CALIFORNIA  
**HIGHLAND ESTATES**  
**LOT 11 IMPROVEMENT PLANS**  
**EROSION CONTROL PLANS**  
 SAN MATEO COUNTY

**Date: April 25, 2016 (Revised – 8/9/17)**

**Re: Planning Comments on Lots 9-11**

**From: Camille Leung, Senior Planner**

Lot 9 Current Plan

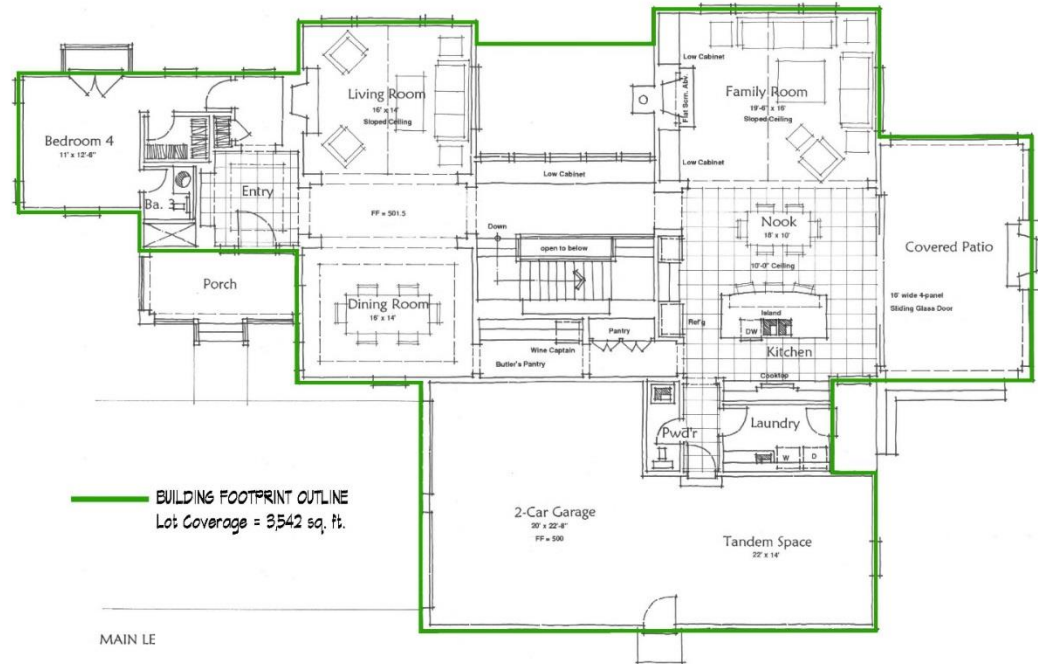
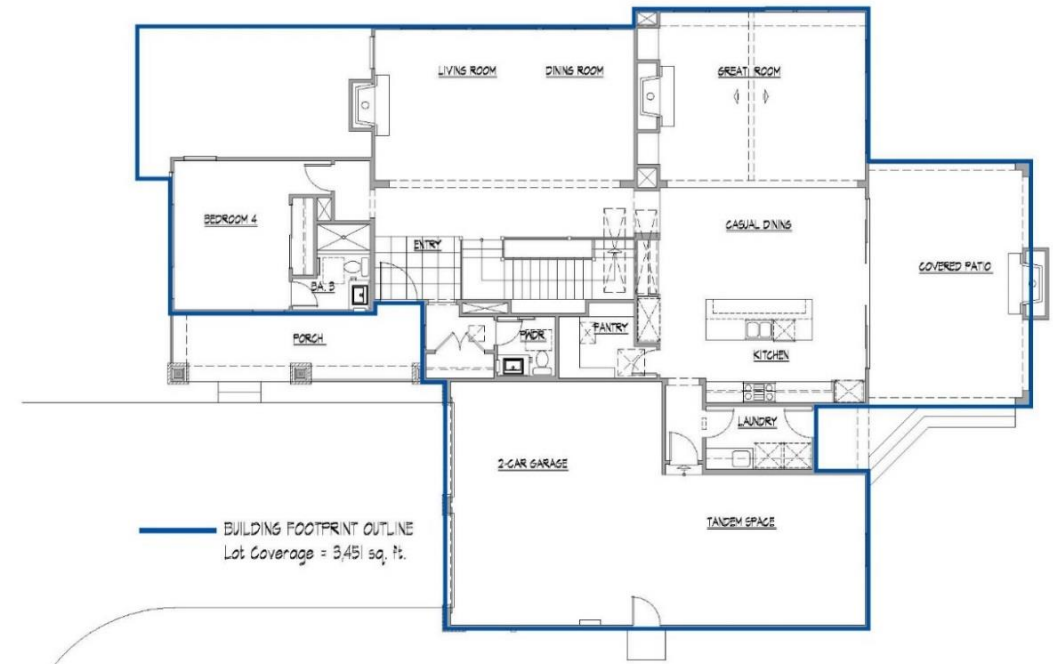
Changes to Footprint for Lot 9: The applicant has consolidated the design of the footprint of the house, resulting in a total footprint reduction of 91 sq. ft.

### Changes to Setbacks and Footprints for Lot 9:

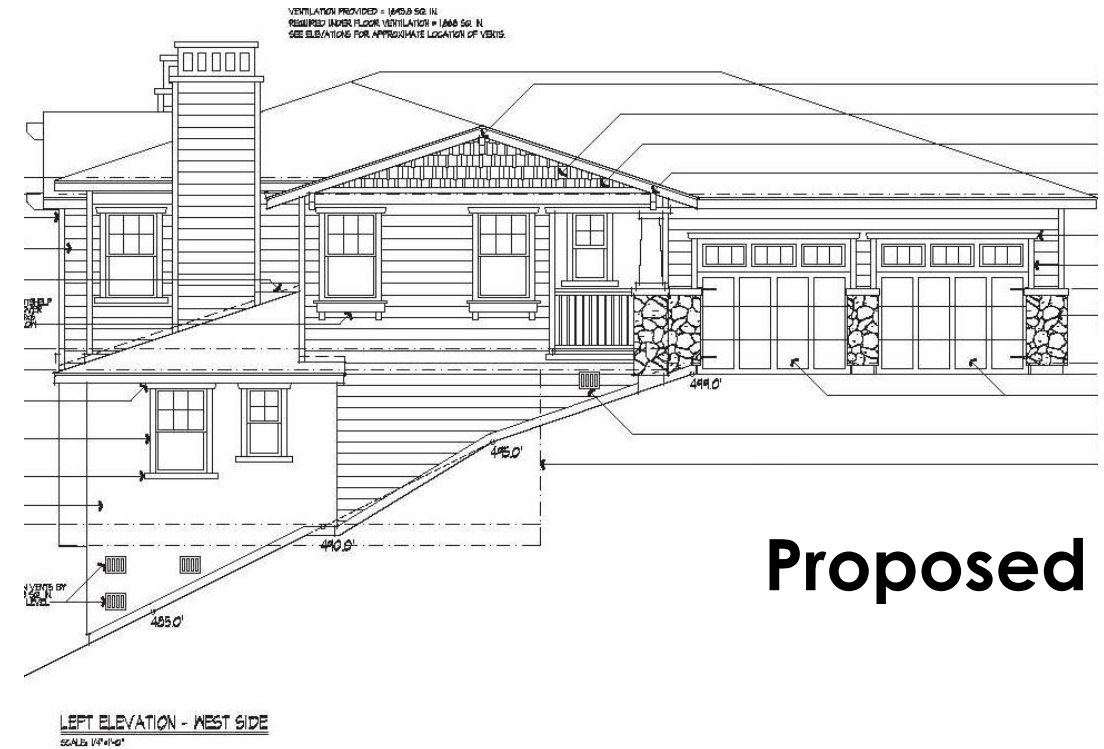
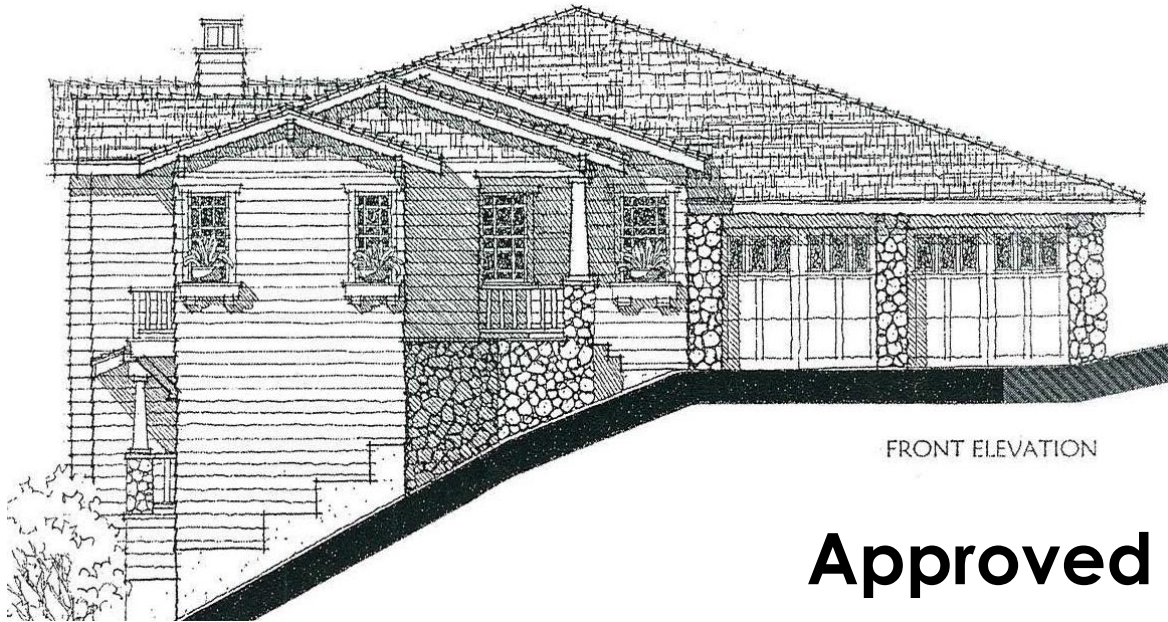
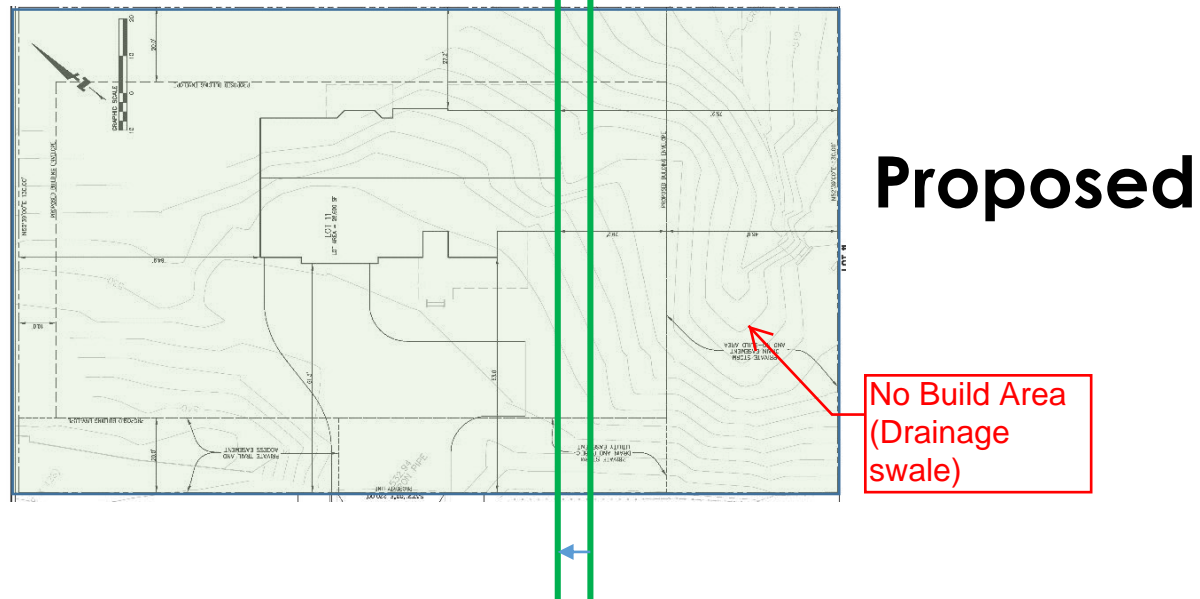
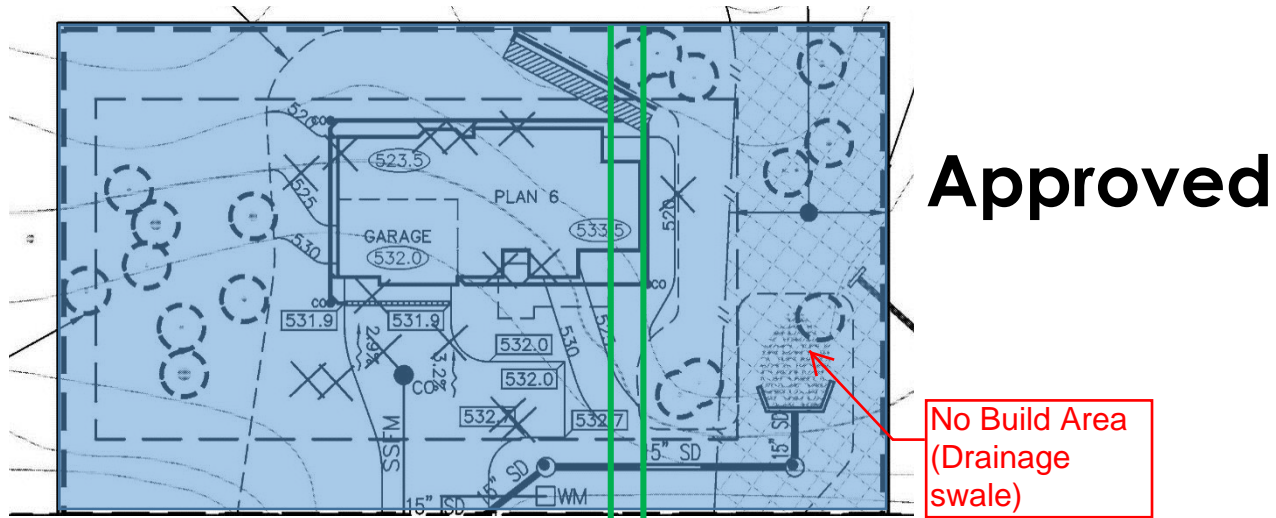
The proposed consolidation of the footprint for the house on Lot 9 resulted in changes to the architectural design of the house.
